Some Questions from the DAQ Group

Tonko Ljubicic/BNL
TOF Meeting, 12-Sep-2023

TOF Slide, Page #19

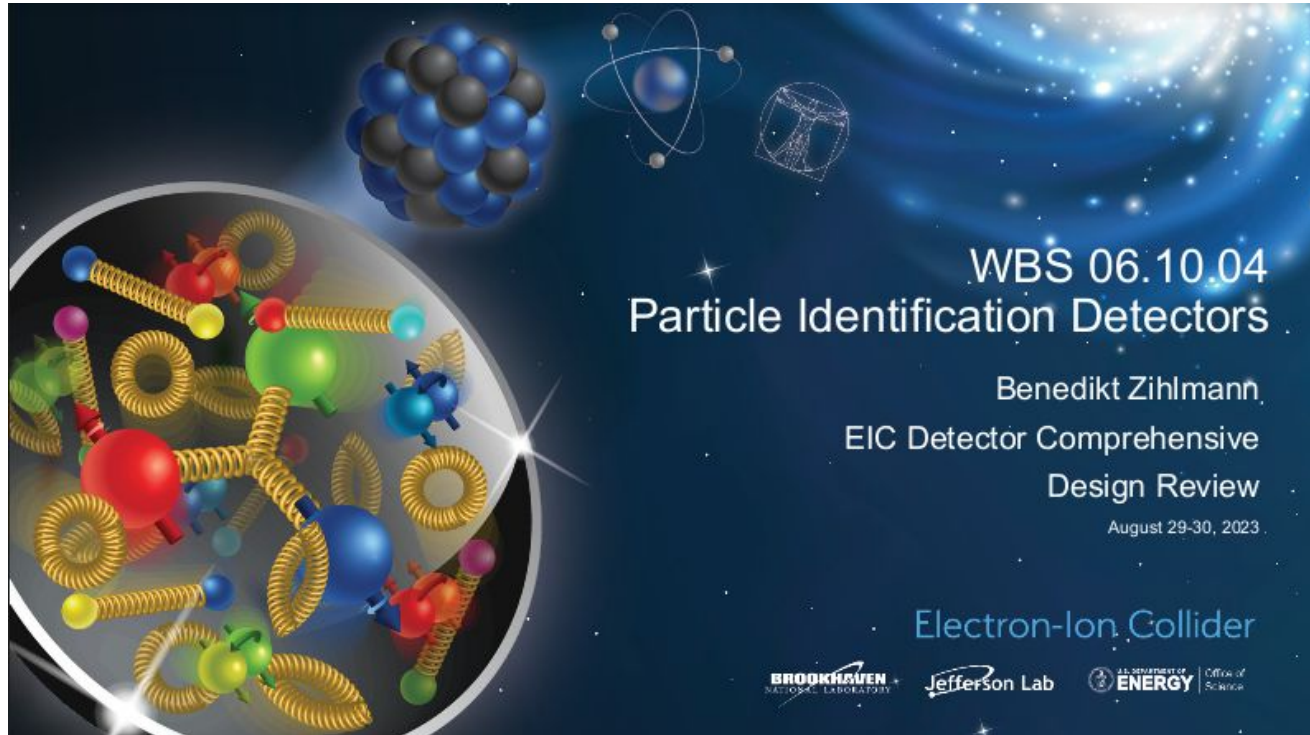
DAQ Group is confused with numbers shown in the presentation below:

TOF counts of channels & RDOs are different in this presentation than what we showed previously.

Barrel: 1 module (stave?) should only have 32 sensors (64x128ch ASICs). There should be 288 modules (aka RDOs) for readout on both sides. **Isn't this the plan??**

Endcap: 1 board (RDO?) has different number of sensors, from 24-48 (average 41), so the total number of channels is not 5.2M but is 8.9M like always. **(Where does the number "25 sensors" come from??)**
